APPLICATION NO.	FILING DATE	FIRST NAMED INVENTOR	ATTORNEY DOCKET NO.	CONFIRMATION NO.
10/774,314	02/06/2004	Shlomo Novotny	SUN.04.142	8526
45774	7590	02/24/2006		
KUDIRKA & JOBSE, LLP ONE STATE STREET, SUITE 800 BOSTON, MA 02109			EXAMINER CHANDRAN, BIJU INDIRA	
			ART UNIT 2835	PAPER NUMBER

Office Action Summary	Application No. 10/774,314	Applicant(s) NOVOTNY, SHLOMO	
	Examiner Biju Chandran	Art Unit 2835

Claim Rejections - 35 USC § 103

FIG. 2

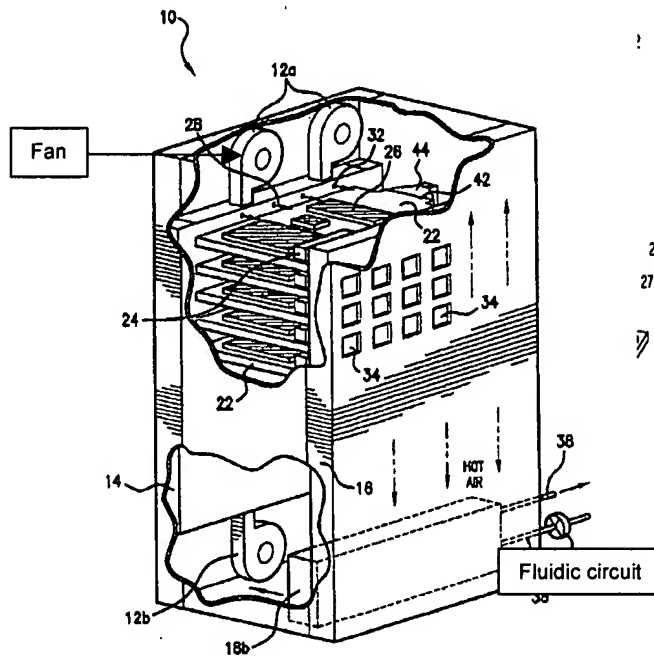
- With respect to claim 1, Patel et al. disclose an electronic component system comprising: an enclosure (10); one or more electronic components positioned within the enclosure (22, 24), at least one fan (12a, 12b) positioned within the enclosure for generating an airflow across the one or more electronic components (paragraph 0031), a heat exchanger for cooling the airflow (18a, 18b, paragraph 0026). While Patel et al. recognize the importance of adequately and reliably cooling the enclosed electronic components (paragraph 0006-0010, also note dual heat exchangers – 18a & b, and dual fans – 12a & b provided for redundancy), and the susceptibility of computer cooling system failure to failure of cooling support systems of the data center housing the computer (paragraph 0010), they do not disclose a phase

- With respect to claim 13, Patel et al. further discloses at least one fan (12a, 12b) that recirculates air within the enclosure (Patel et al., paragraph 0025).

- With respect to claim 26, Patel et al. disclose a cooling system comprising of an enclosure (10), one or more electronic components positioned in the enclosure (22, 24); means for generating an airflow (12a, 12b) across the one or more electronic components, cooling means for cooling the airflow (18a, 18b, paragraph 0026). While Patel et al. recognize the importance of adequately and reliably cooling the enclosed electronic components (paragraph 0006-0010, also note dual heat exchangers – 18a & b, and dual fans – 12a & b provided for redundancy), and the susceptibility of computer cooling system failure to failure of cooling support systems of the data center housing the computer (paragraph 0010), they do not explicitly disclose a phase change material positioned within the enclosure in the airflow generated by the fan. O'Grady discloses a phase change material for absorbing heat from the airflow upon a failure in the cooling means (failure of cooling support systems of the data center housing such computers as mentioned in column 1, lines 20-25), positioned in the airflow. It would have been obvious to one of ordinary skill in the art at the time the invention was made to incorporate the phase change material taught by O'Grady in the electronic component system taught

- With respect to claim 27, Patel et al. further discloses that the means for generating the airflow includes a fan (12a, 12b).
- With respect to claim 28, Patel et al. further discloses that the cooling means includes a fluid to air heat exchanger (Patel et al., Paragraph 0026).

Fig. 6

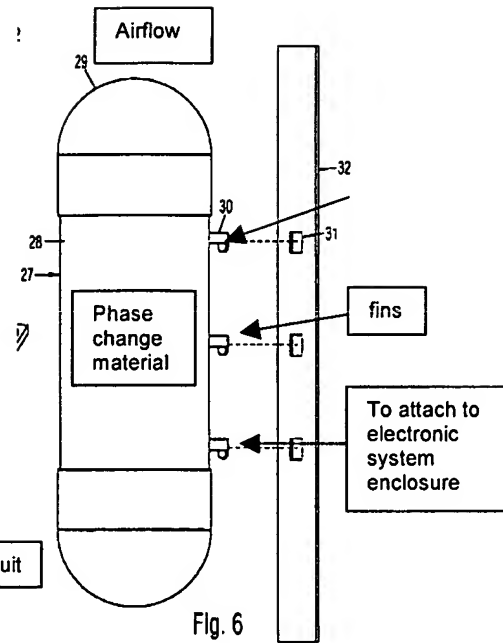
change material exposed to the airflow within the enclosure generated by the fan for absorbing heat from the airflow upon a failure associated with the heat exchanger. O'Grady (US patent 6,170,561) disclose a back up cooling device for electronic components comprising a phase change material for absorbing heat from the airflow upon a cooling system failure (failure of cooling support systems of the data center housing such computers as mentioned in column 1, lines 20-25) associated with electronic component systems. It would have been obvious to one of ordinary skill in the art at the time the invention was made to create a system for permitting orderly shutdown of electronic components by incorporating the phase change material taught by O'Grady in the electronic component system disclosed by to Patel et al., so as to provide repair time by delaying electronic component failure after cooling system failure (O'Grady, column 2, lines 25-30).

- With respect to claim 8, O'Grady further discloses that the container includes fins (O'Grady, Fig 6, "30").
- With respect to claim 11, Patel et al. further discloses a temperature sensor for sensing temperature within the enclosure; and a high temperature indication indicative of a high temperature within the enclosure (Patel et al., Paragraphs 0033-0035), the high temperature being lower than a phase change temperature of the phase change material (O'Grady, lines 50-55).

- With respect to claim 31, O'Grady further discloses that the phase change material is enclosed in a container (O'Grady, "11").
- With respect to claim 32, O'Grady further discloses that the container includes fins (O'Grady, Fig 6, "30").

where there is some teaching, suggestion, or motivation to do so found either in the references themselves or in the knowledge generally available to one of ordinary skill in the art. See *In re Fine*, 837 F.2d 1071, 5 USPQ2d 1596 (Fed. Cir. 1988) and *In re Jones*, 958 F.2d 347, 21 USPQ2d 1941 (Fed. Cir. 1992). In this case, Patel et al. (US 2003/0147216 A1) discloses a self contained cooling system for high power electronic systems, recognizing the importance of providing a "complete integrated data center that houses, cools and powers, and networks electronic components", minimizing the reliance on cooling facilities of the computer room (end of paragraph 0009), since a failure or shutdown of the facilities cooling system can lead to failure of the electronic components and costly consequences for the user (end of paragraph 0010 on page 1). Therefore, Patel et al. ensures redundancy in the cooling equipment within the enclosure by providing multiple heat exchangers and fans. However, the cooling system of Patel et al. is still susceptible to failure of the cooling system components that are outside the enclosure, for instance, the 'remote chiller' (50) and related conduits (136). Meanwhile, O'Grady (US patent 6,170,561) disclose a back up cooling device for electronic components comprising a phase change material for absorbing heat from the air stream upon a cooling system failure (electrical, mechanical, and plumbing system failures of the data centers that house electronic components, as mentioned in column 1, lines 20-25). The failures that O'Grady seeks to protect against are the same type of failures that Patel et al. is susceptible to. O'Grady's also indicates that his phase change material is applied to computer cabinets (third embodiment shown in figure 6 and described in column 4, lines 25-30). Although O'Grady does not explicitly say that

the device with the phase change material '27' is deployed inside the computer cabinet, his illustration in figure 6 indicates that it would be (since mounting rails – similar to mounting rail '20' of Patel et al.- exists inside the computer cabinet). Also, it would have been obvious to one of ordinary skill in the art to incorporate the teaching of O'Grady into the system disclosed by Patel et al. That is, to incorporate the teaching of the phase change material as disclosed by O'Grady within the enclosure disclosed by Patel et al., since Patel et al. do point out the virtues of providing a completely integrated enclosure with minimal reliance on facilities cooling (paragraphs 0009-0019, 0027).

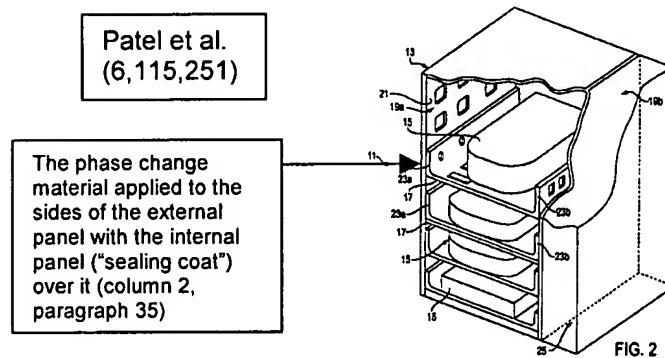
surfaces within the enclosure. Fitch et al. disclose a phase change material in microencapsulated form that is embedded in a coating applied to one or more surfaces within an electronic system enclosure (Fitch et al., abstract, figure 8, column 5, lines 4-7). At the time the invention was made, it would have been obvious to one of ordinary skill in the art, to incorporate the micro-encapsulated phase change material coated on multiple surfaces of the enclosure as taught by Fitch et al., on the system as taught by Patel et al. and modified by O'Grady, to make utilize the additional cooling capabilities of the micro-encapsulated surface coating without a significant increase in weight, size and cost (Fitch et al., column 3, lines 10-15).

However, Fitch et al. does indicate an electronic apparatus that has the inside surface of the enclosure coated with a microencapsulated form of phase change material (Title, abstract, figure 9 and its description).
